From: [Wells, Shelly, EMNRD](#)
To: ["Ashton Thielke"](#)
Cc: [Ashton Thielke](#); [Laci Luig](#); [Bratcher, Michael, EMNRD](#)
Subject: RE: [EXTERNAL] Cimarex - nAPP2521358117 RED HILLS UNIT 81H - Alternative 400sqft Sampling Plan
Date: Thursday, December 18, 2025 9:28:00 AM
Attachments: [image001.png](#)

Proposed Excavation Depth Map

nAPP2521358117

Red Hills Unit #081H (08.01.2025)

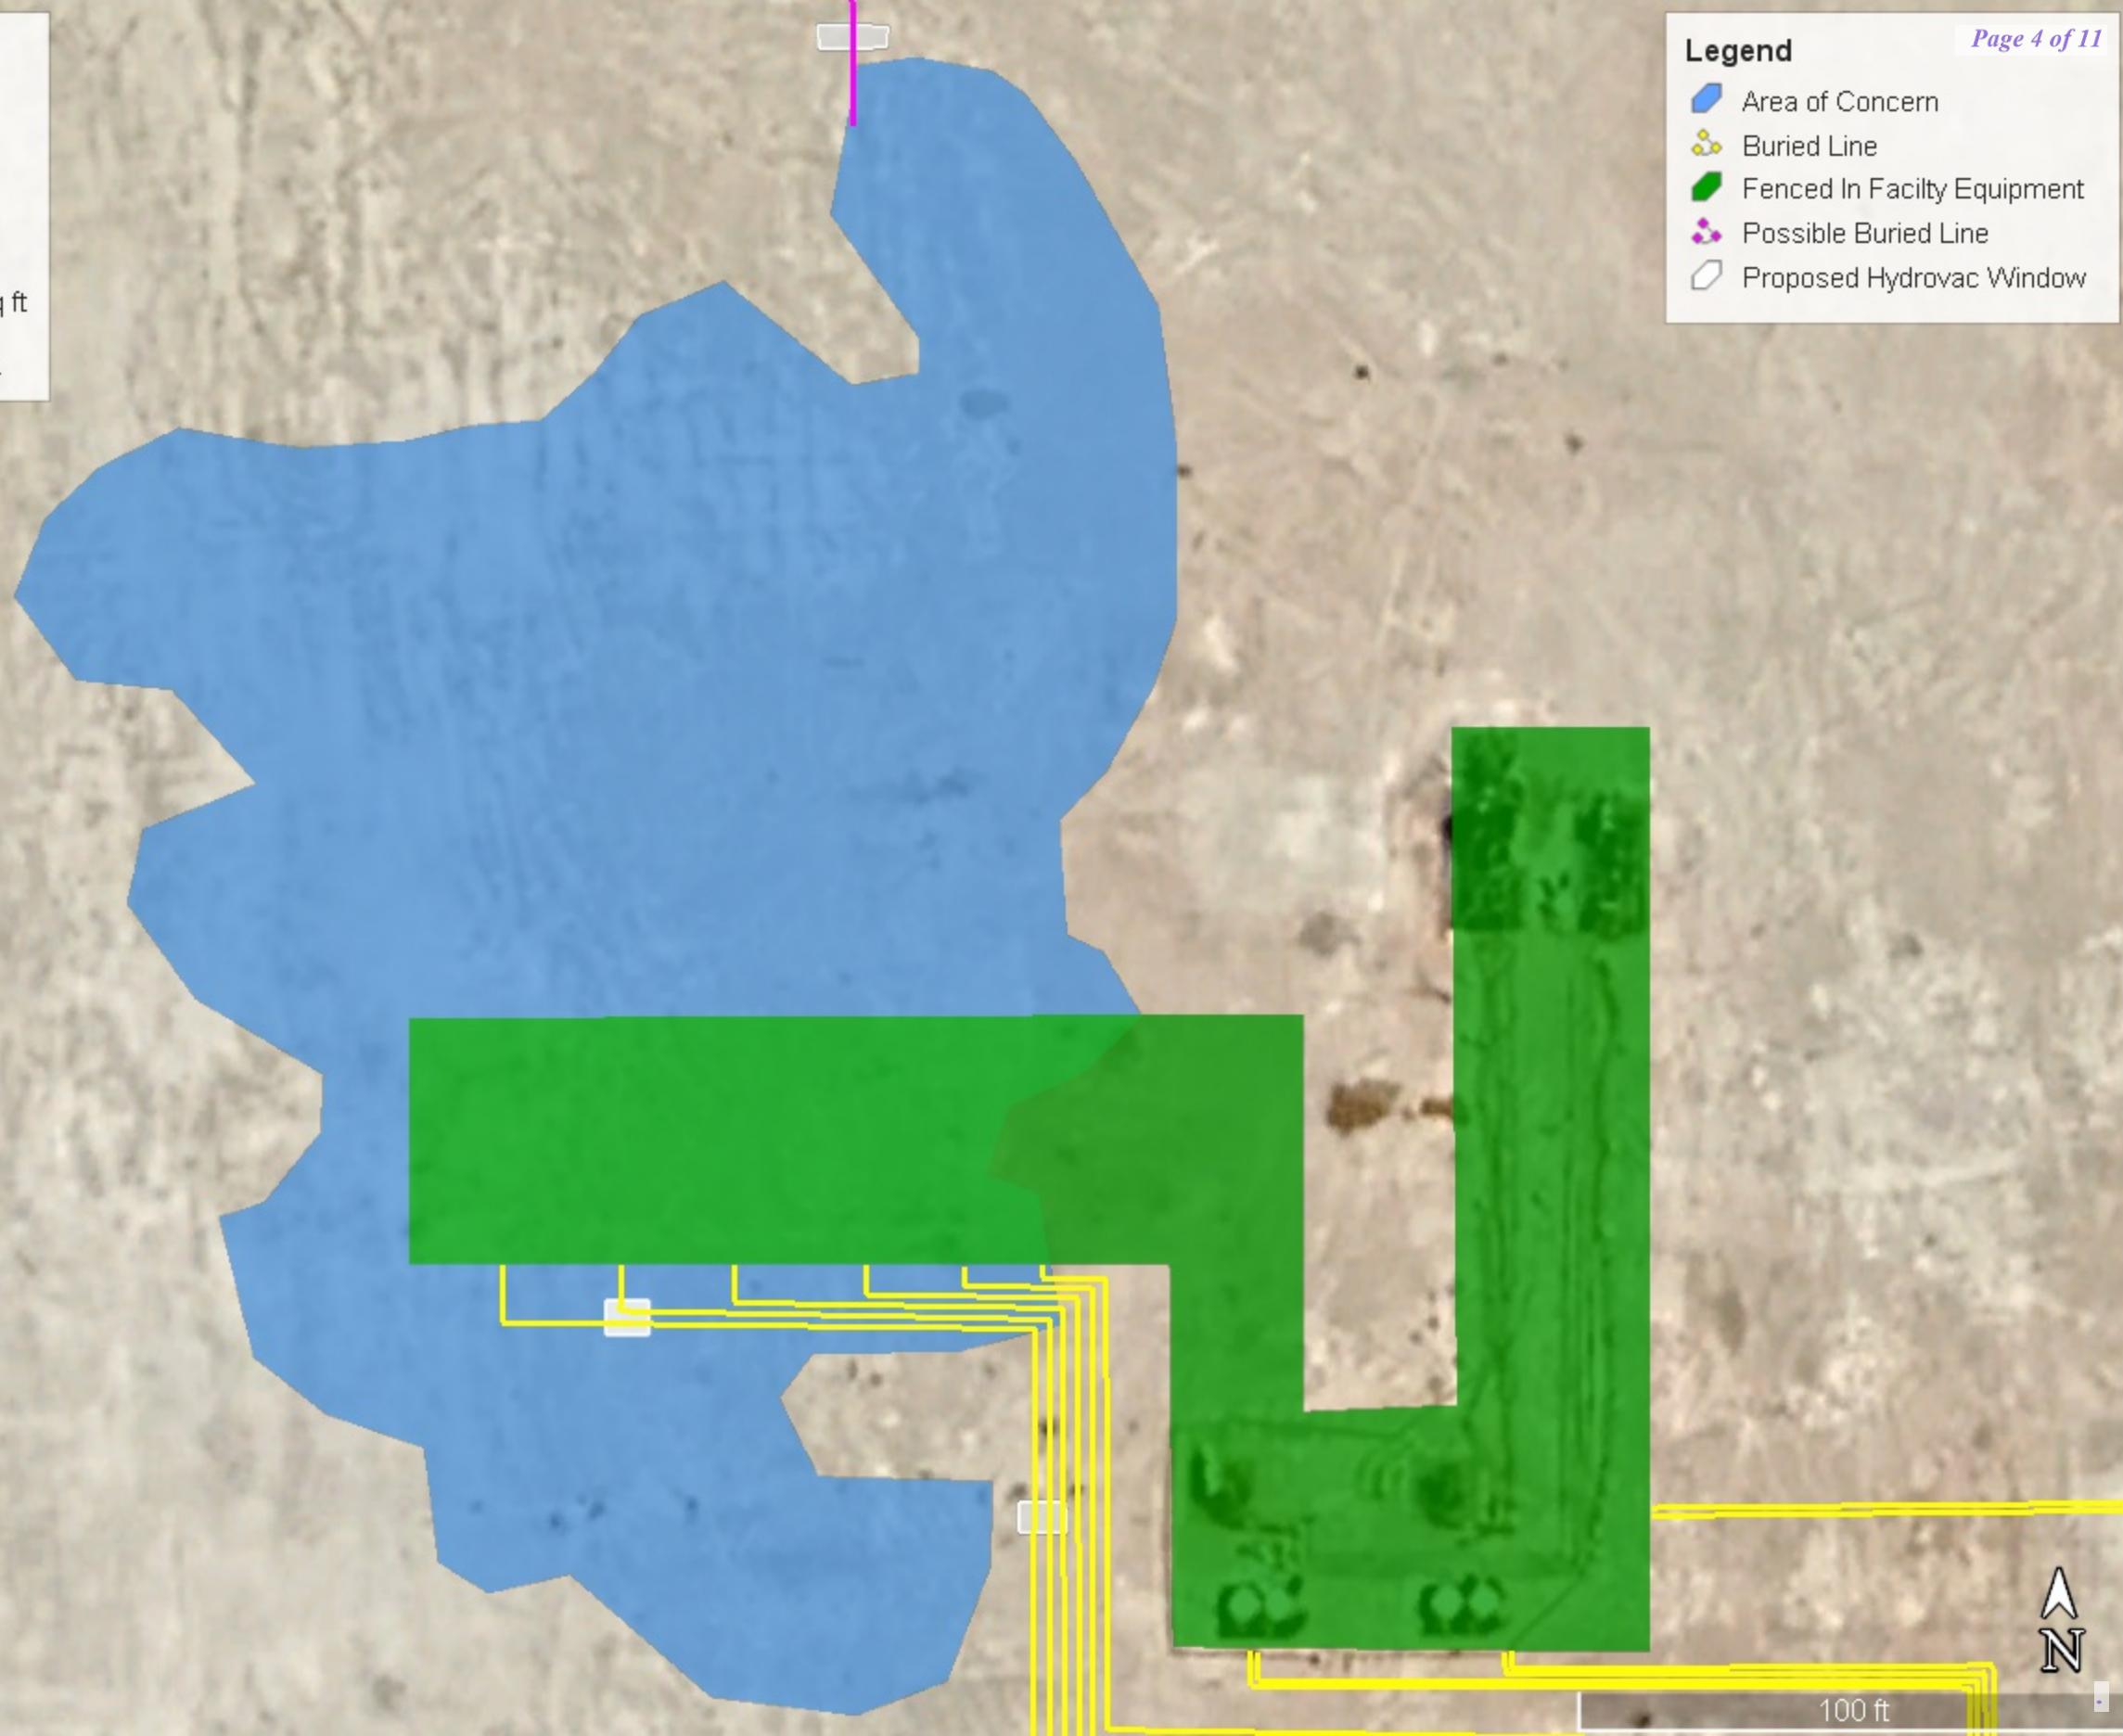
The above mentioned release has now been made available as fracking operations have ceased and the well pad location is safe for remediation and sampling operations to begin. We are planning on going onsite to revisit the release area, conducting a surface scrape to a depth between 4-6 inches and begin composite confirmation sampling.

Due to this excavation being less than 1 foot in depth, we will be collecting horizontal "grab" samples immediately outside of the scrapped area to horizontally define the release area.

On behalf of Cimarex Energy Co. of Colorado, Carmona Resources is requesting an increase in the composite floor sampling frequency from the standard 200 square feet to 400 square feet. The release occurred on pad and was contained to the well pad location.

If approved, we plan on being onsite between December 23, 2025 & December 24, 2025 to collect composite confirmation surface samples from inside the release area to represent no more than 400 square foot as well as horizontal "grab" delineation samples surrounding the previous release area.

Your request to use an alternative sampling plan is approved. Please include a copy of this and all notifications in the report to ensure the notifications are documented in the project file.
